RE: Notice of Violation, Mallinckrodt US LLC, Bureau of Remediation and Waste Management

AMENDED NOTICE OF VIOLATION

**Subject: Plant Area CMI Plan, Concrete and Utility Removal, Addendum 5
Orrington Remediation Site
Orrington, Maine**

CMI PLAN - CONCRETE AND UTILITY REMOVAL-ADDENDUM 5

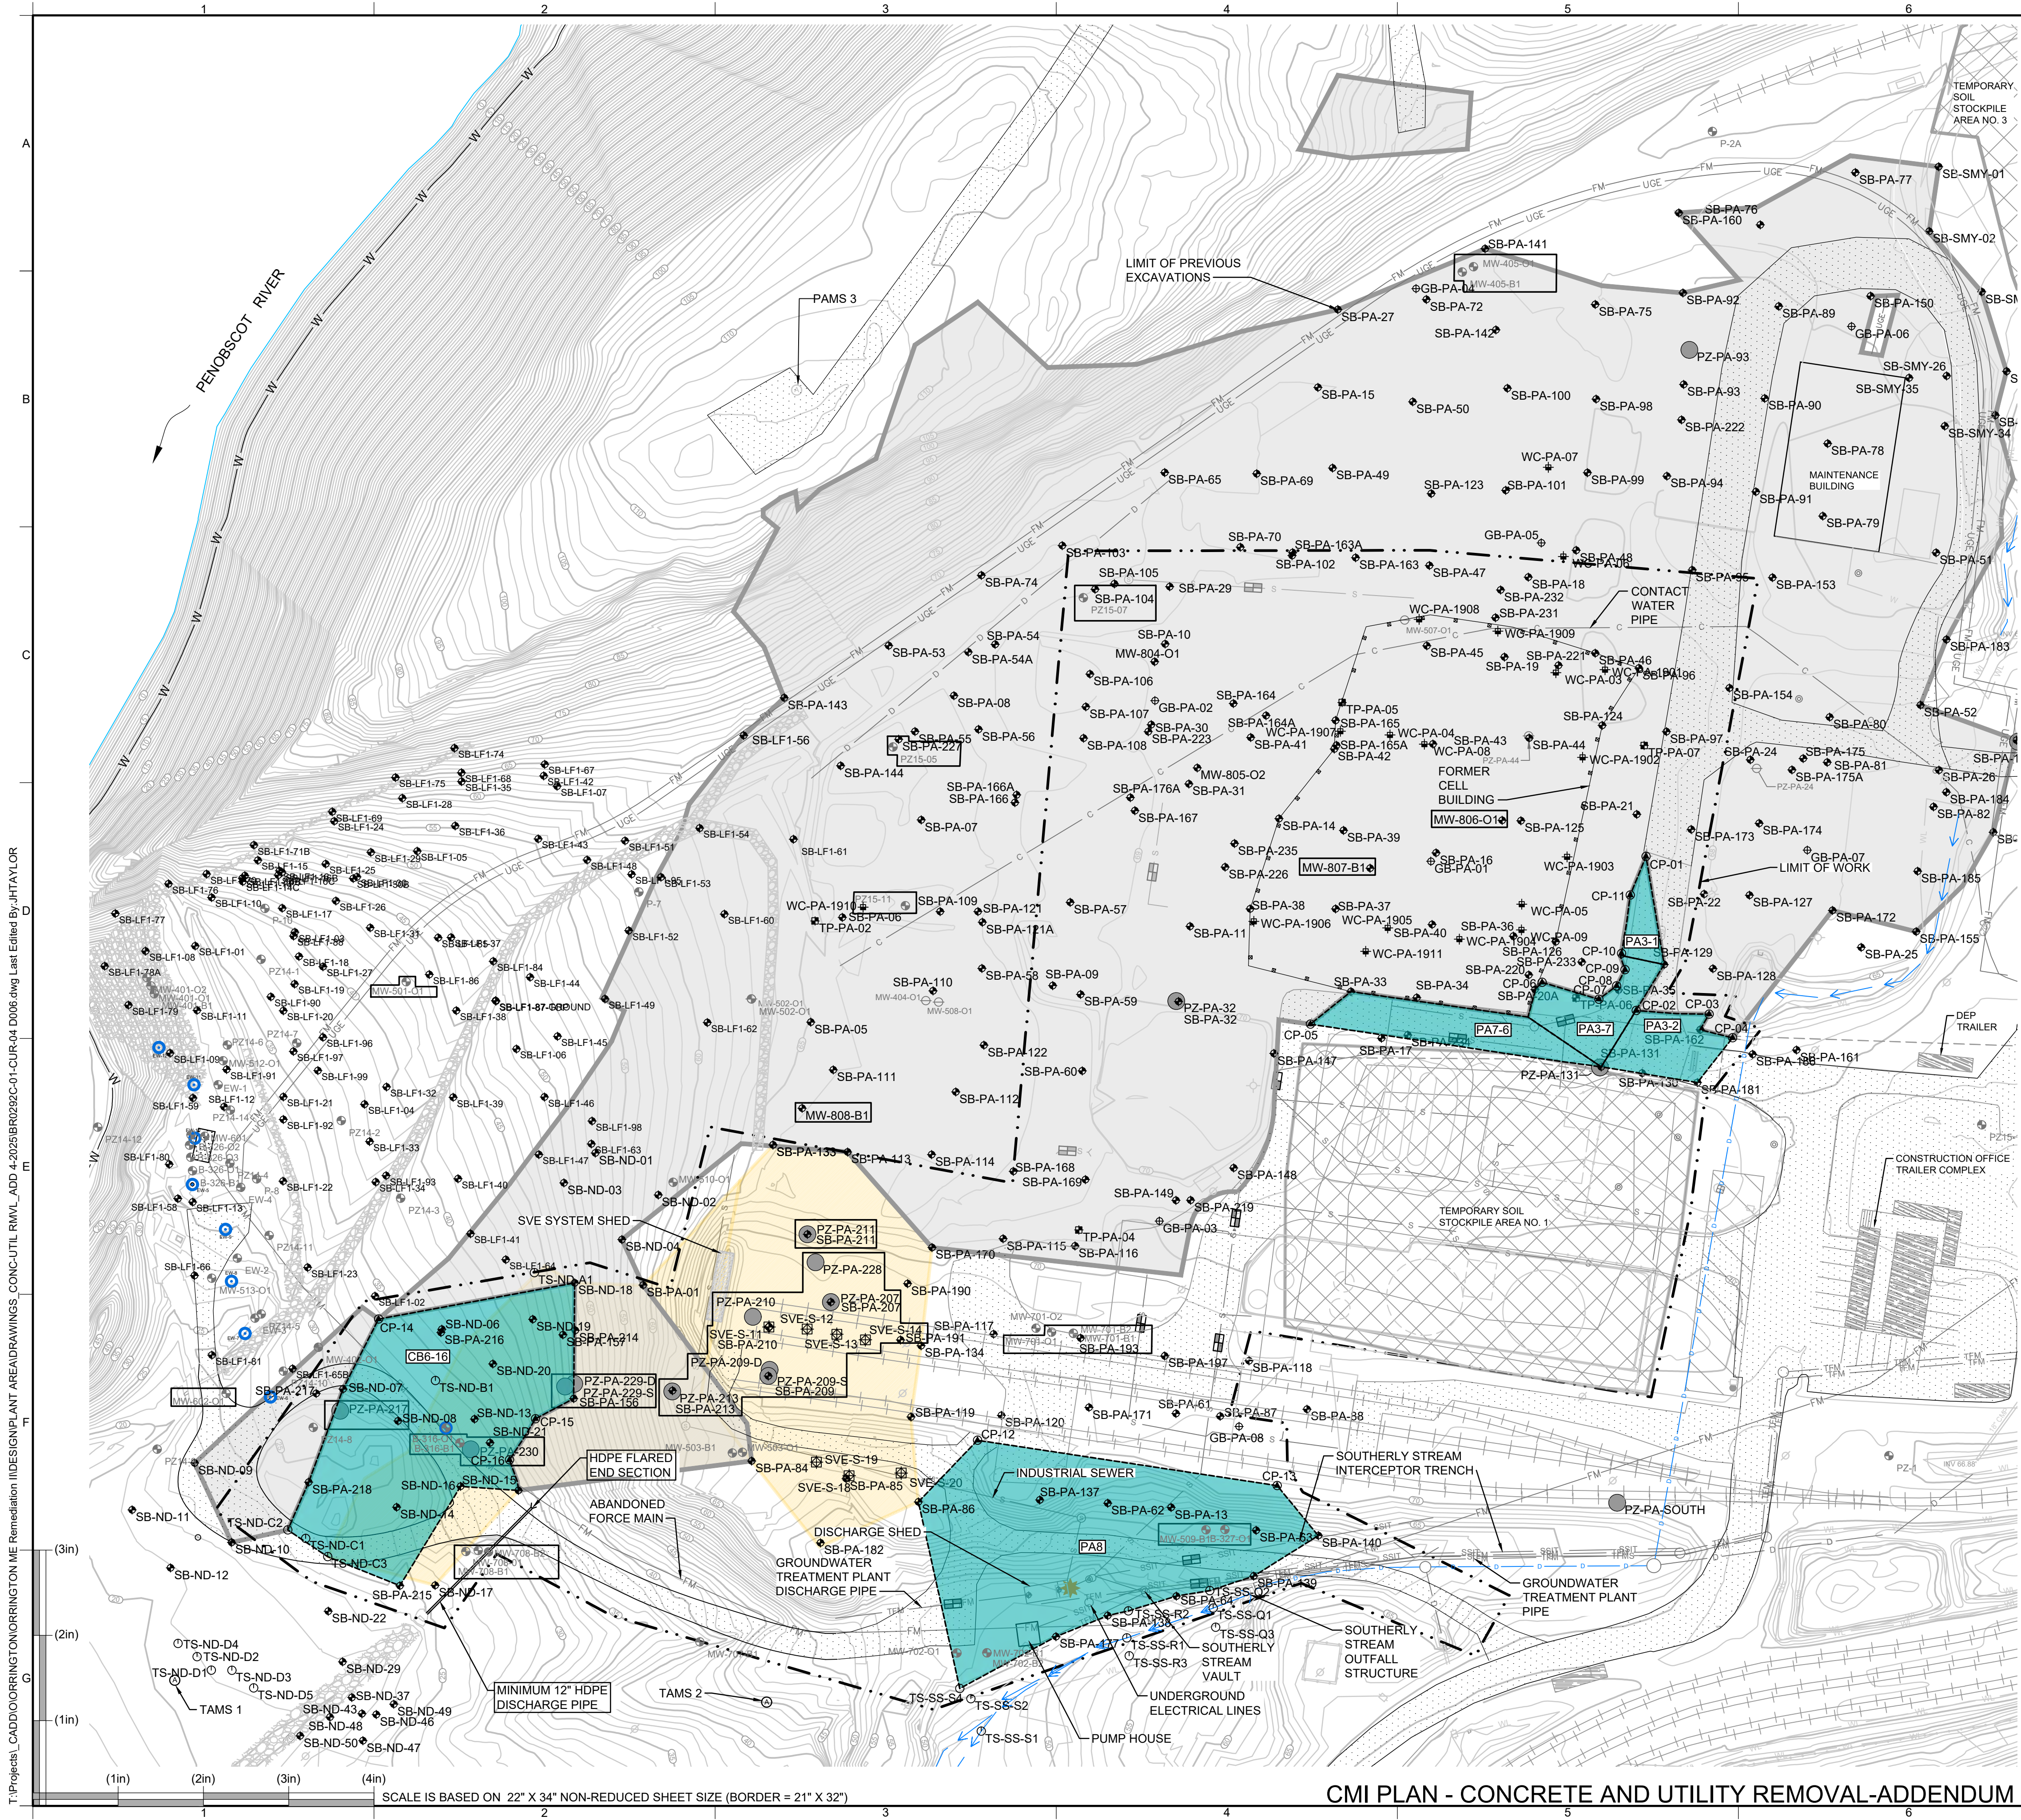
29. Mallinckrodt's Addendum 5 for the Plant Area did not incorporate DEP's modifications to the Plant Area CMIP. Instead, Addendum 5 proposes that Mallinckrodt would only excavate to 4 feet in depth in six specific areas on the site: PA3-1, PA3-2, PA3-7, PA7-6, PA8, and CB6-16. Notably, Mallinckrodt continues to evade the clear requirement that it remove all soils at the Site that exceed the MPS of 2.2 ppm for mercury to protect public health, safety, and the environment.

(e.g. through manholes or vaults)” remaining portions of the industrial sewer in the Plant Area. DEP has interpreted this as Mallinckrodt intending to retain all industrial sewer lines not under the six specific areas that it deems inaccessible and abandon-in-place any lines within these areas or “accessible” on the remaining portion of the Site that are located at depths greater than 4 feet. This would fail to comply with the DEP Orders which require removal of the industrial sewer.¹⁷ Through this Amended NOV, DEP requests Mallinckrodt either clarify or confirm its proposed approach to removal of industrial sewer at the Site.

1. Within 30 days of receipt of this NOV, submit for the DEP's review and approval a detailed work plan to remove all solid material above the Site MPS from all unremediated areas within the Plant Area.

2. Within 30 days of the receipt of this NOV, submit for the DEP's review and approval a detailed work plan to remove all industrial sewer on the Site.

# Plant Area Site Plan of Approximate Locations of Visible Hg and Soil with Hg > MPS, Except the Former Cell Bldg Area, March 7, 2025

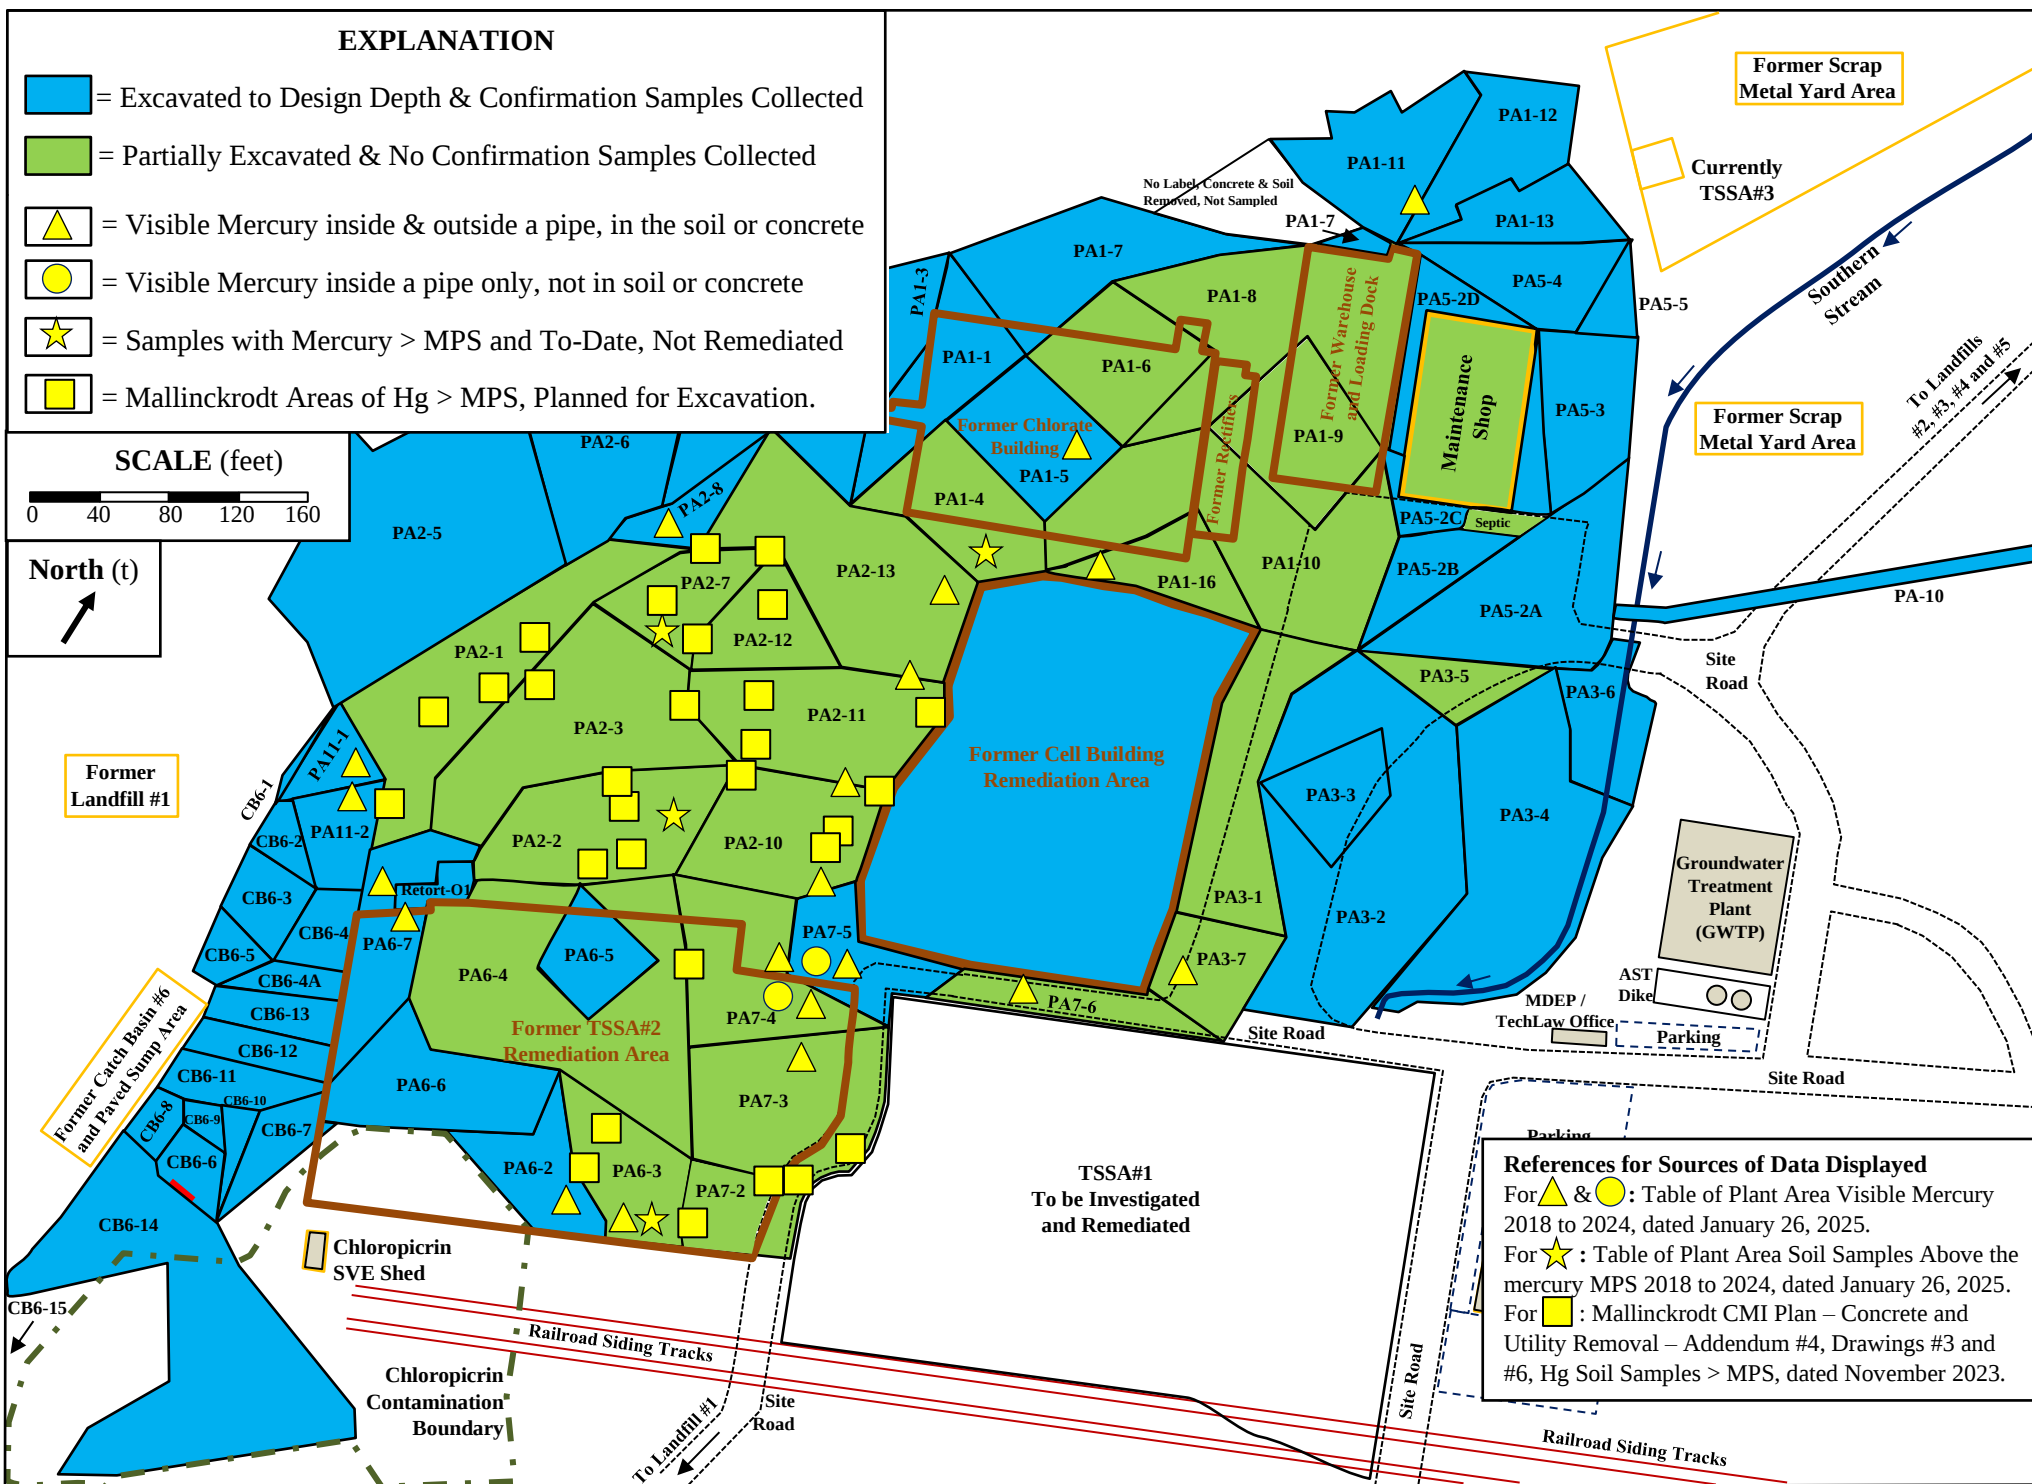
20. The DEP determined that Mallinckrodt's November 2, 2023, Plant Area CMIP was non-compliant with the DEP Orders and the DEP's June 2, 2023, letter because the Plant Area CMIP did not address remediation of all soils exceeding the mercury MPS at the Site, as required by the DEP Orders.¹³

21. Mallinckrodt's proposed November 2, 2023, Plant Area CMIP is inconsistent with the DEP Orders and departs from the DEP's approved remediation practices at the Site in several ways. Specifically, Mallinckrodt's proposed Plant Area CMIP artificially limits the locations where excavations would be performed by proposing to excavate small areas (20 ft X 20 ft) rather than entire cells as had been done with all previous excavations at the Site. The proposed Plant Area CMIP also limits the depth of excavation to no more than two feet below the depths of soil exceedances in boring samples, rather than continuing excavation until all sample results are less than the MPS of 2.2 ppm, as required by the DEP Orders and as has been done at all previous excavations at the Site other than Landfills 1 & 2. Mallinckrodt also proposes limiting excavations to a depth of 15 feet below ground surface, even though previous investigations and excavations have determined that soils exceeding the Site's MPS of 2.2 ppm for mercury have been found at greater depths in the Plant Area.

¹³ See Plant Area Site Plan of Approximate Locations of Visible Hg and Soil with HG > MPS compiled by TechLaw, March 7, 2025.
